Office of the Special Inspector General for Afghanistan Reconstruction

August 1, 2017

John F. Sopko
Special Inspector General for
Afghanistan Reconstruction (SIGAR)
Herbert Smith, Mission Director
Mission Response to Draft Alert Letter titled: "Structural
Damage at Health Facility 2132" (SIGAR SP-173/SIGAR
17-XX-SP)
SIGAR Transmittal email dated 07/18/2017

Photo 5: Internal damage and cracks at Health Facility 2132

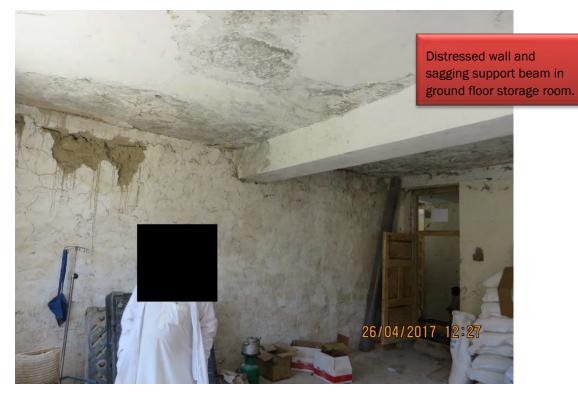
As seen in the photos below, SIGAR engineers found the beams, column, and roof of the facility are severely damaged, and that clinic staff used wooden beams to temporarily support the roof.

USAID thanks SIGAR for alerting us to the structural damage at Health Facility 2132. USAID has informed the Afghan Ministry of Public Health (MoPH) and the World Bank of the situation through official letters dated July 23, 2017.
